# International Aero Engines SERVICE BULLETIN

Subject: Transmittal of Revision 1 to Service Bulletin No. V2500-ENG-71-0119

ENGINE - POWER PLANT - INTRODUCE REVISED EEC HARNESS  
CLIPPING TO PROVIDE SUFFICIENT CLEARANCE BETWEEN  
HARNESS AND FLANGE FD IN AREA ADJACENT TO EEC

**V2500-ENG-71-0119**

Figure 1

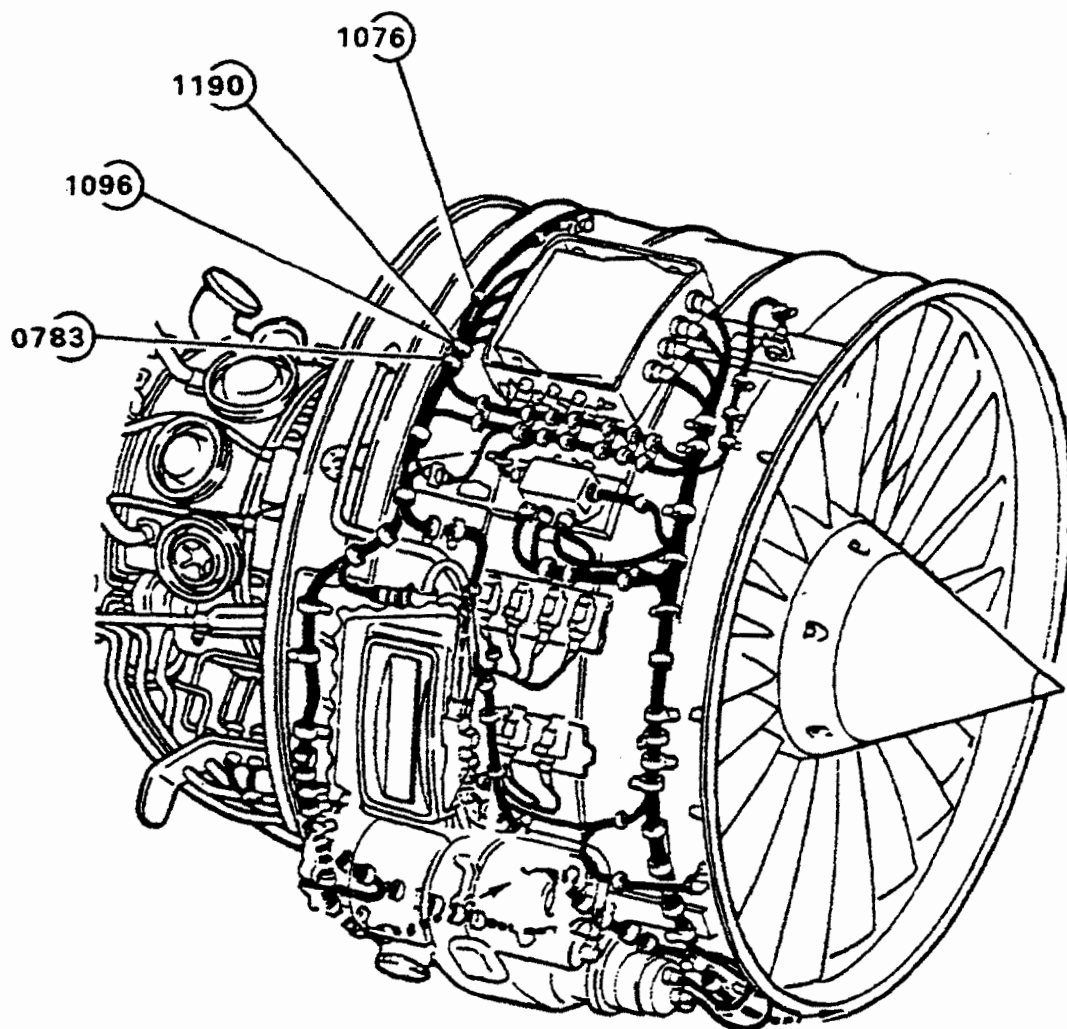
- (1) The EEC harness is re-clipped between clip points 0796 and 1075.
- (2) Clip points 0783 and 1076 are altered, clip point 1096 is deleted and clip point 1190 is added.
- (3) The brackets at clip points 0783, 1076 and 1096 are deleted and three new brackets are added at clip points 0783, 1076 and 1190.
